**Proposed Temporary Shop and Services with Ancillary Facilities and
Associated Filling of Land for a Period of 3 Years in "Agriculture" Zone,
Various Lots in D.D. 107, Kam Tin, Yuen Long, New Territories**

(S.16 Planning Application No. A/YL-KTN/1280)

**Submission for Compliance with Approval Condition (d)
- the Submission of a Drainage Proposal**

**Proposed Temporary Animal Boarding Establishment for a Period of 5 Years
and Filling of Land in "Agriculture" Zone, Lots 946 S.K, 946 S.L, 1119 S.A,
1119 S.B and 1120 (Part) in D.D. 107, Fung Kat Heung, Yuen Long**
(Application No. A/YL-KTN/851)

D01

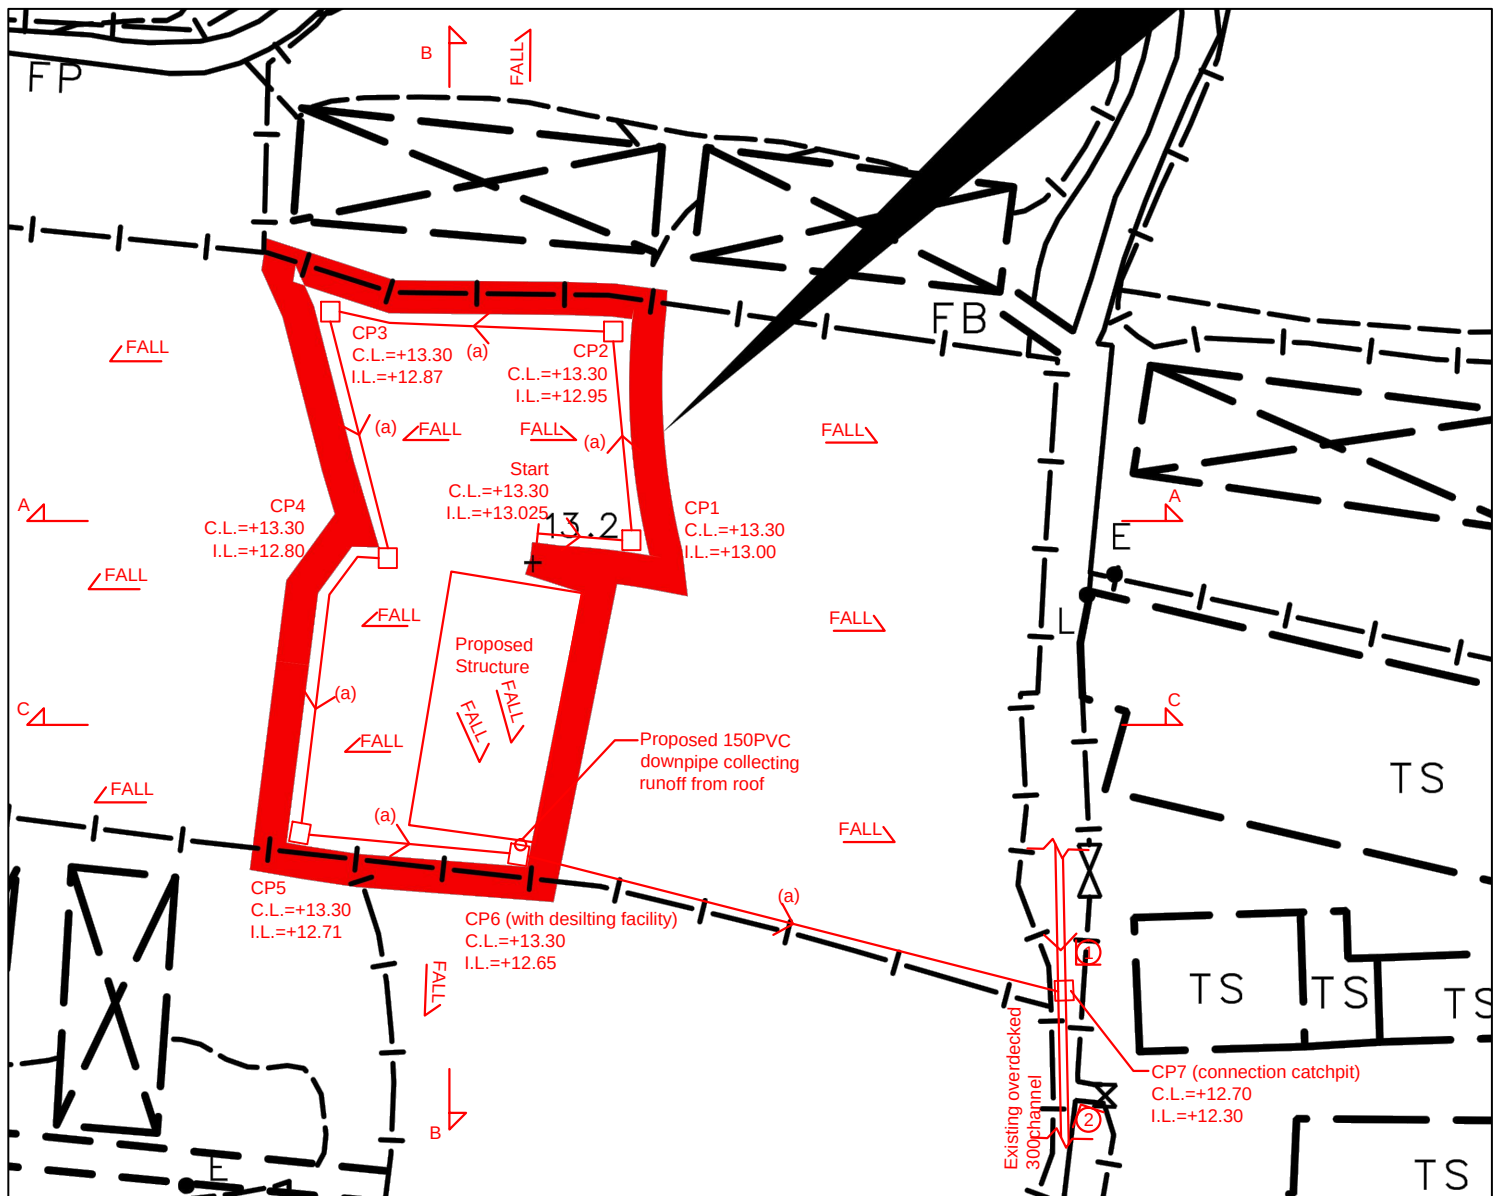
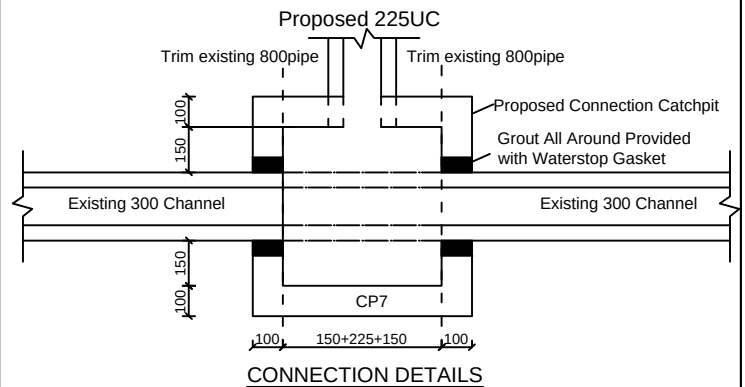
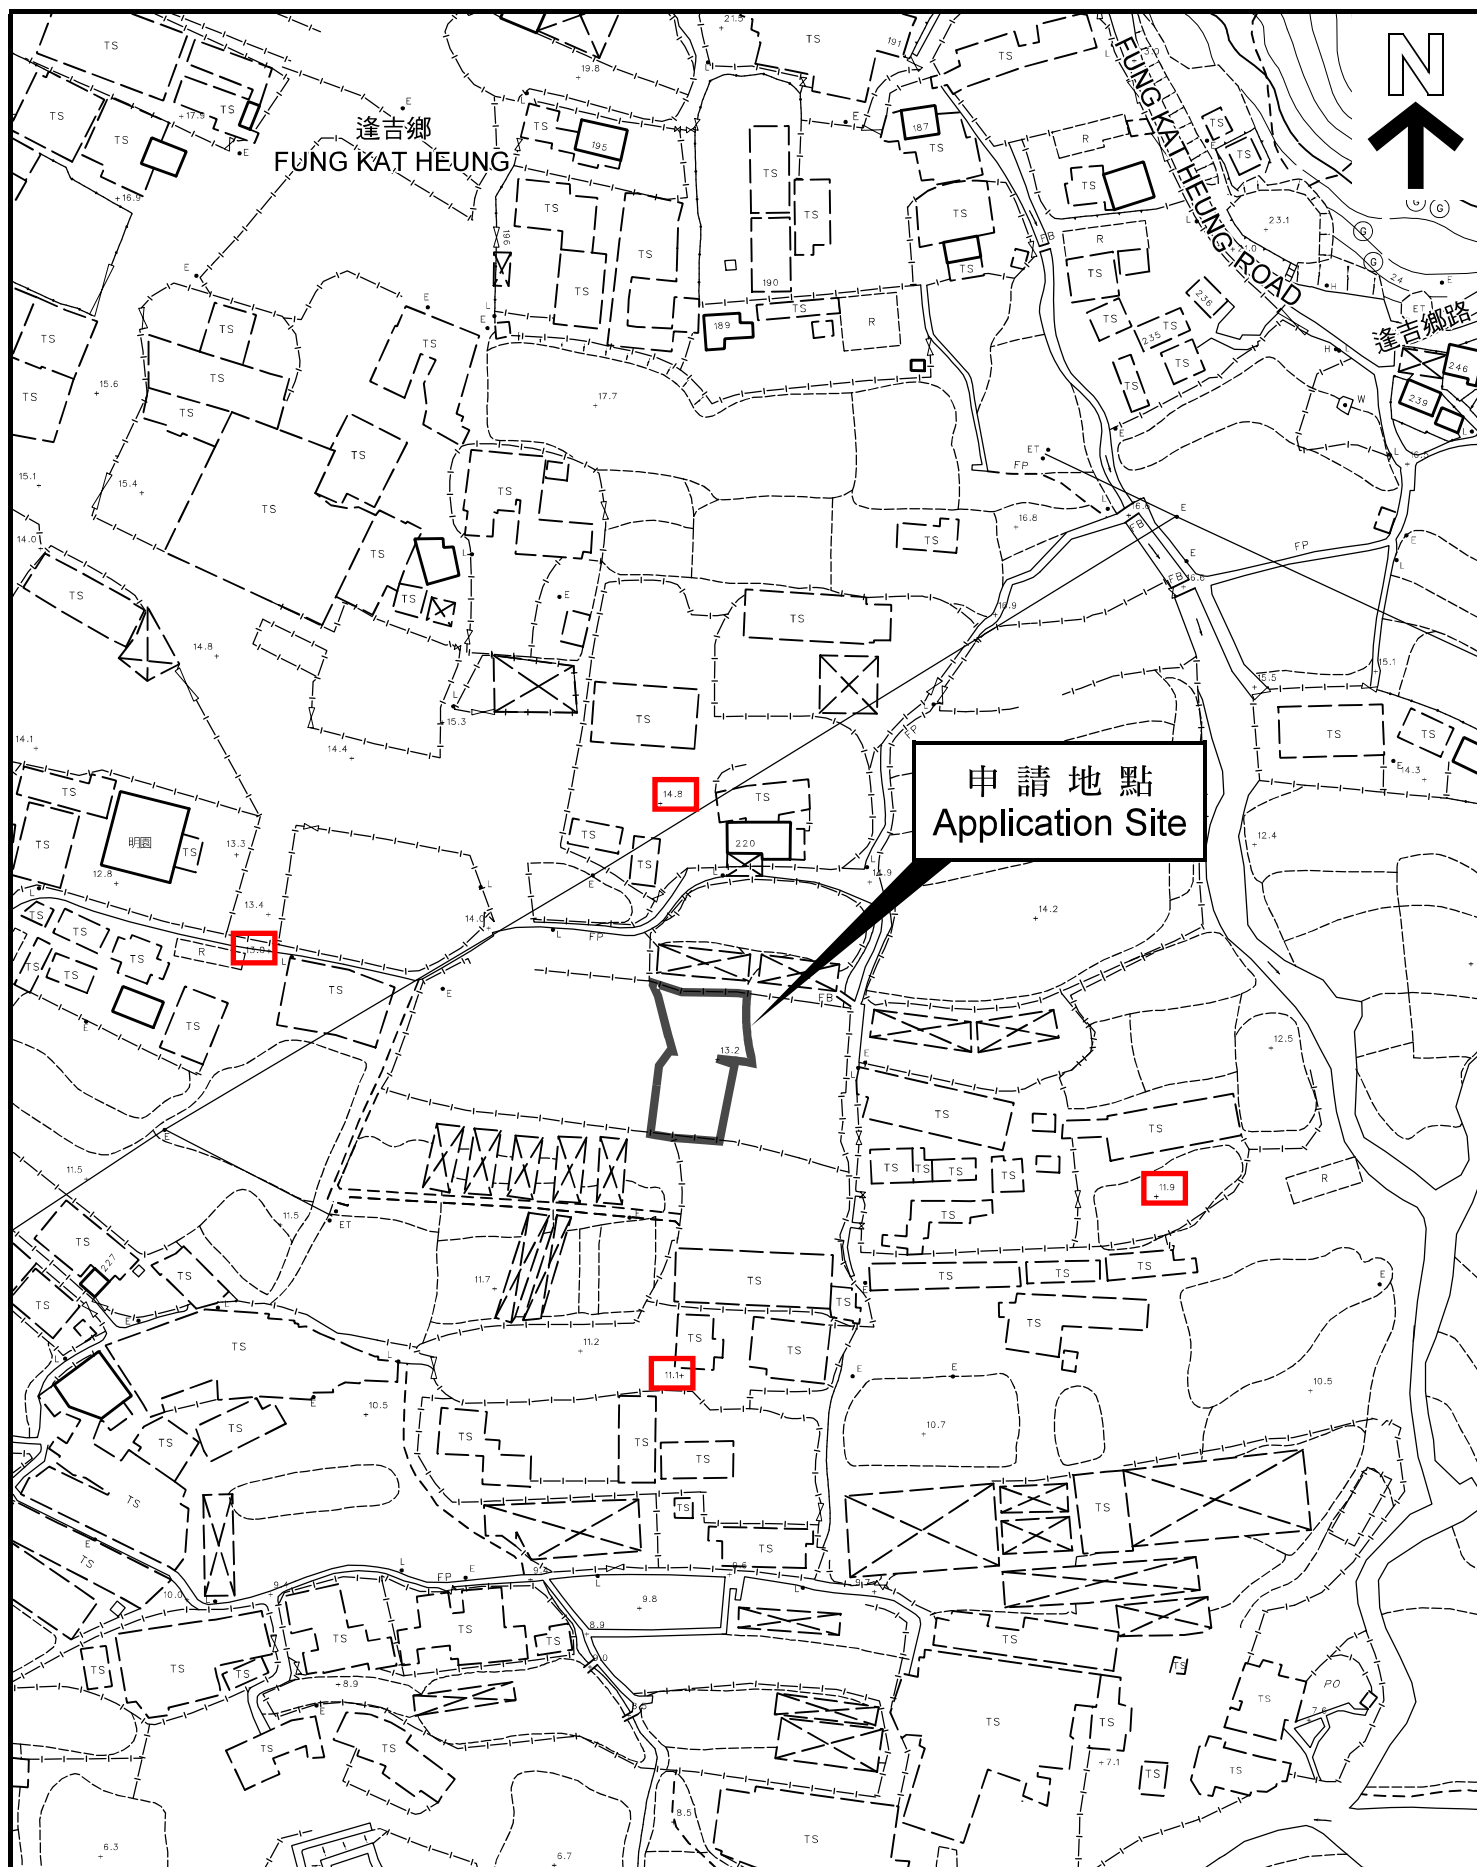
4.	D01: Flow direction of external areas should be shown on plan.	Noted. Flow direction of external areas is indicated on the plan.
5.	Figure 8.7: The value of capacities of channels does not tally with the calculated value on D01.	Noted. It is revised accordingly.

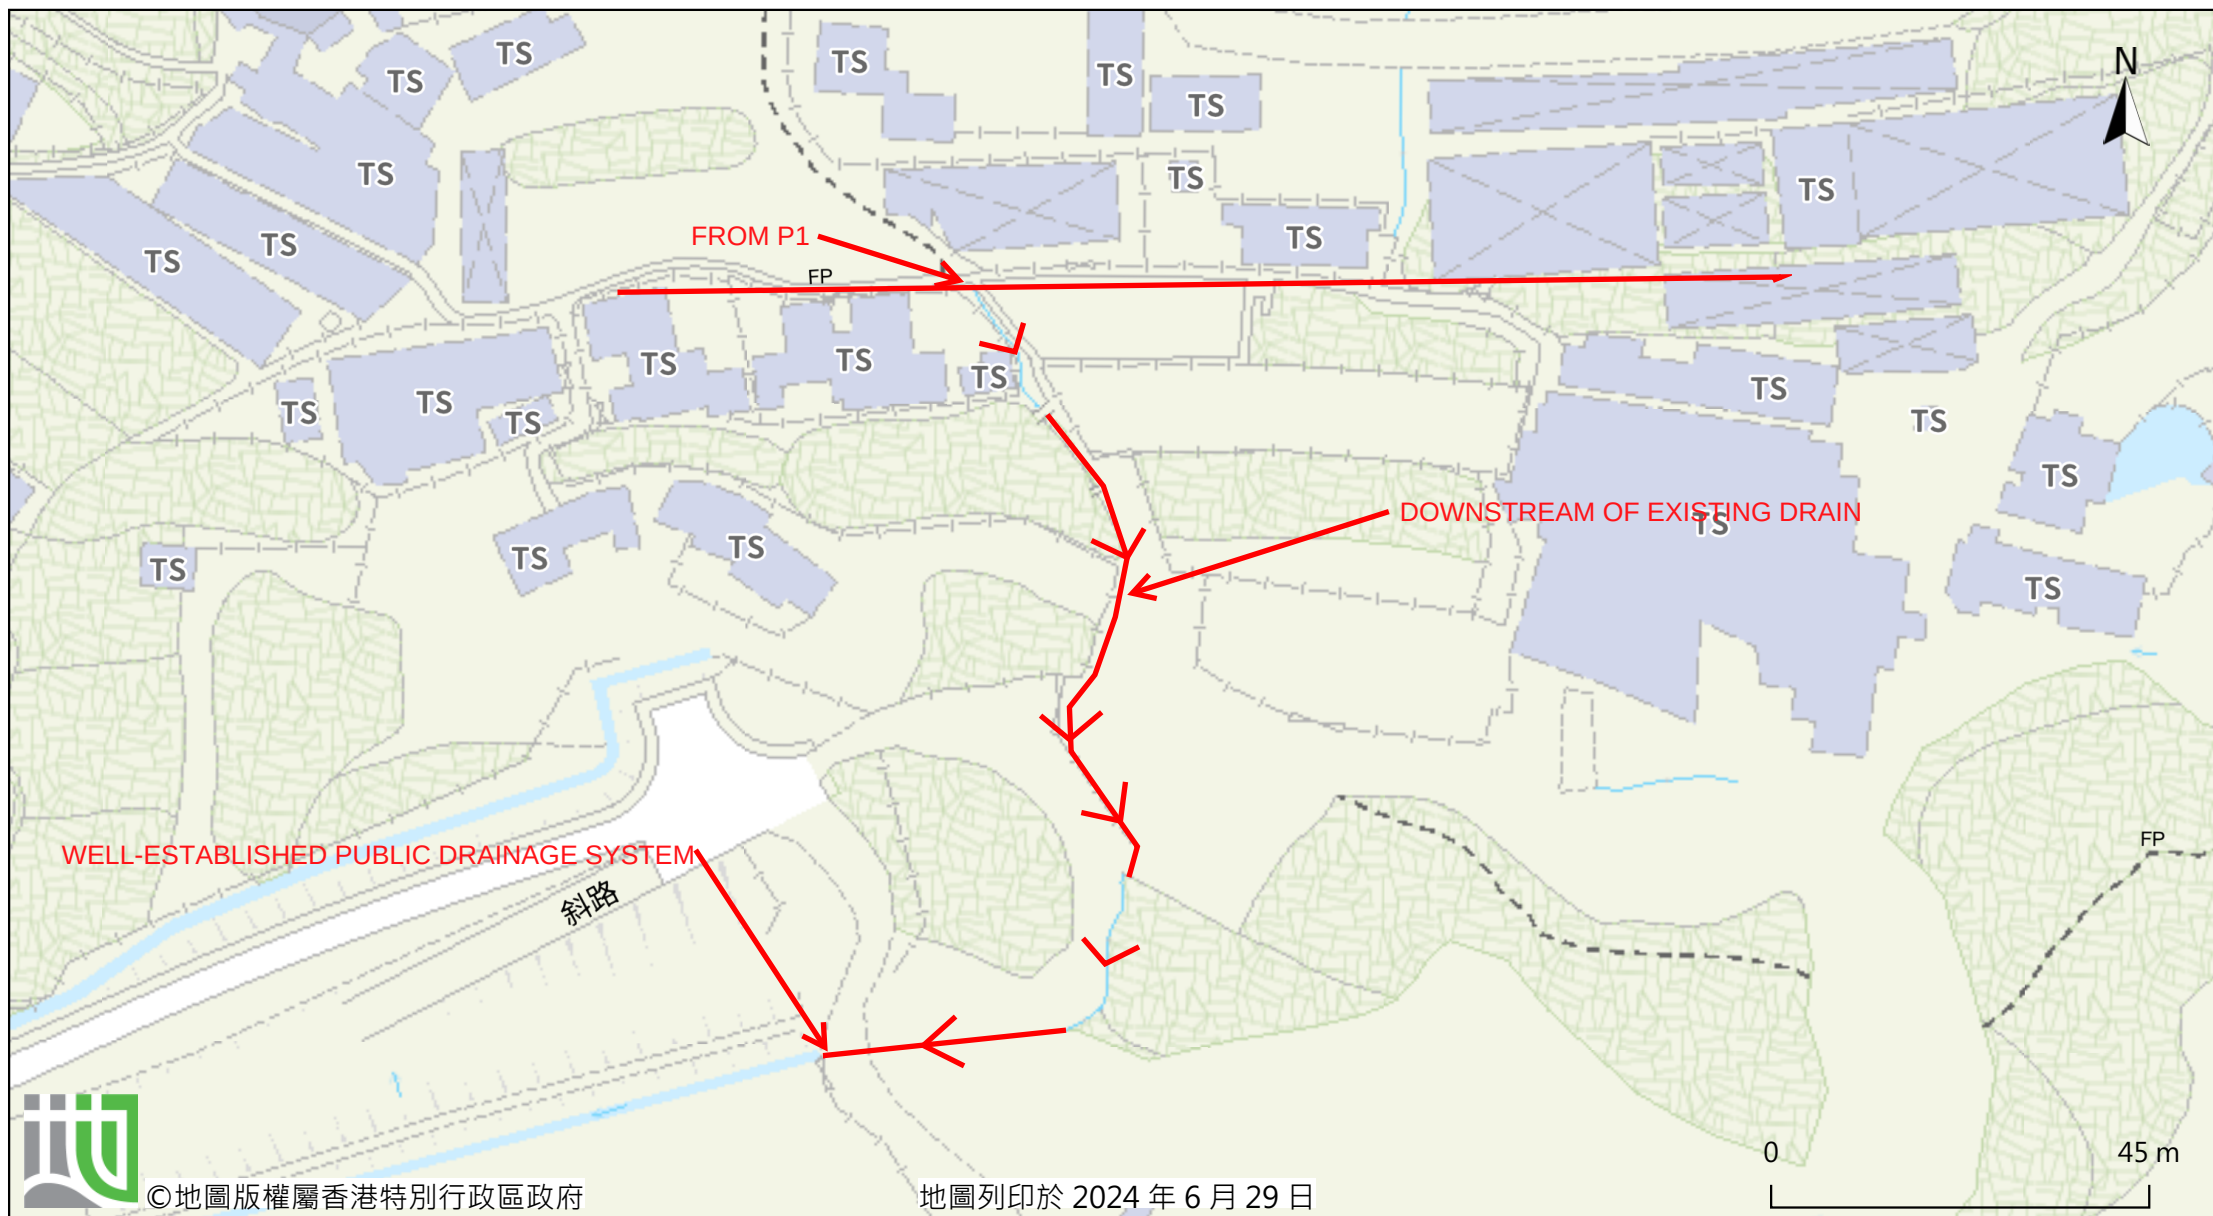
Comments of the Chief Engineer/Mainland North, Drainage Services Department (CE/MN, DSD) (Contact Person: Mr. Terence TANG; Tel: 2300 1257)		
1.	Section A-A: Please advise where is the proposed 225UC on +12.70mPD platform. It does not tally with drainage plan.	Noted. It should be at the existing overdecked 300channel. It is revised accordingly.

2.	Section A-A: Please place a ruler to show there is 550mm level difference, as advised in the section.	Noted. Ruler is placed to indicated 550mm level difference.

3.	Sectopm C-C: Please justify the ground level +13.25mPD. In the absence of well justification of the ground level, peripheral drains adjacent to the proposed structure in the eastern side of site are required.	Noted. It should be +13.20mPD. The level of the eastern side is the same as the site before, which the site is paved with 100mm concrete pavement. Justification is provided in page 3 of the proposal.
